Commonwealth Edison

Subject: LaSalle County Station Unit 2
Facility Operating License NPF-18
Condition No. 4 of Attachment 2
NRC Docket No. 50-374

Enclosed please find the revised LGA Procedures Generation Package (PGP) in response to the questions included in the Draft Safety Evaluation Report.

DRAFT SAFETY EVALUATION REPORT
PROCEDURES GENERATION PACKAGE
LASALLE COUNTY STATION, UNITS 1 AND 2

LGA - G3

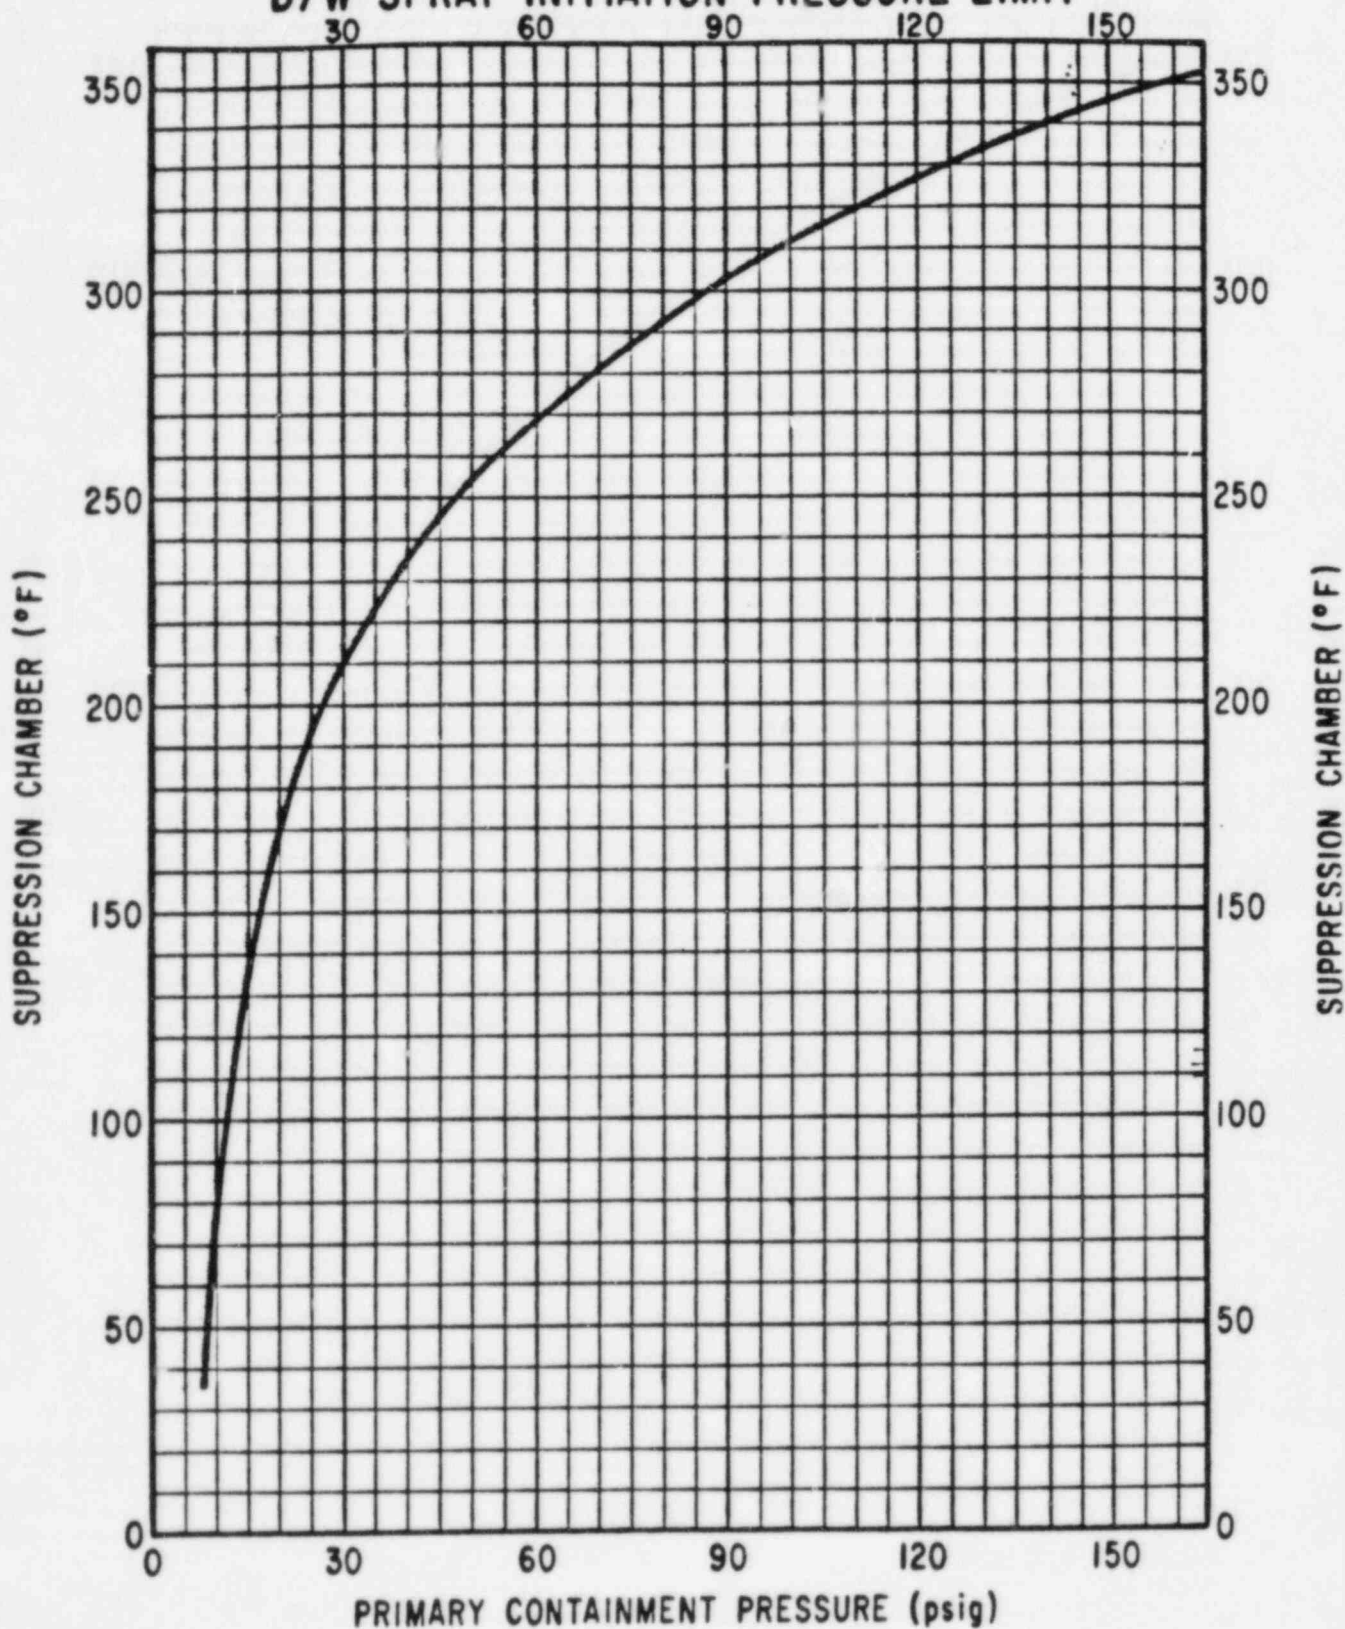
3. For procedural step DW/T-3, page PC-5 of the Technical Guideline, a discussion of the bases for the drywell spray initiation pressure limit-rated spray and the derivation of Figure 4, should be provided.

A per calculation C8

14.4.4 Primary Containment Pressure Limit

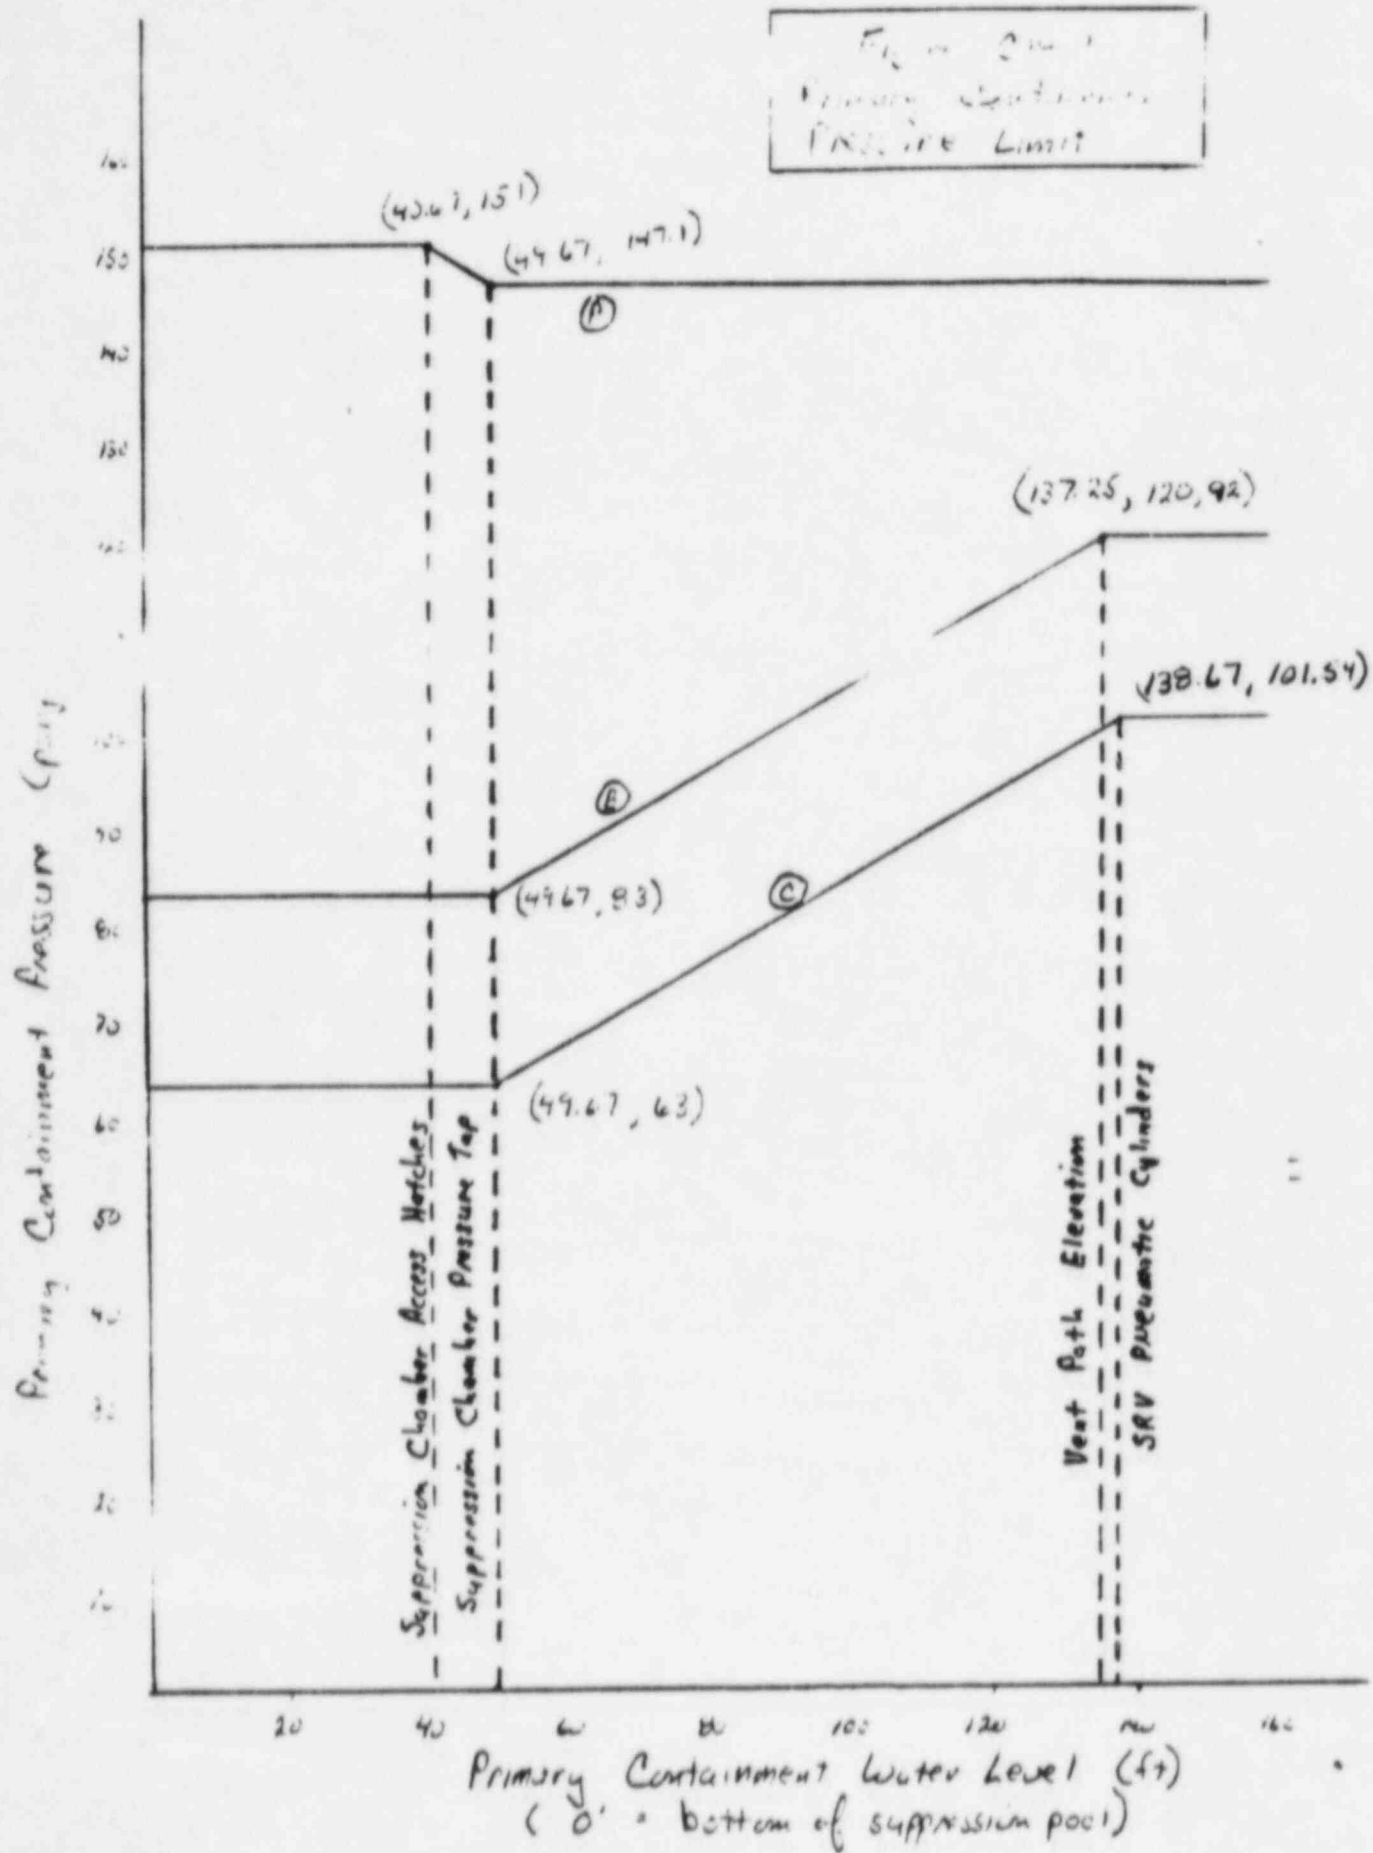
4. In order for us to determine if the value for the "Primary Containment Pressure Limit" shown in Figure C14-1 is acceptable, a discussion of the basis should be provided. The discussion should include consideration of structural analyses and tests, purge valve operability, automatic depressurization system operability, vent capacity requirements, and limitation of offsite release rates.
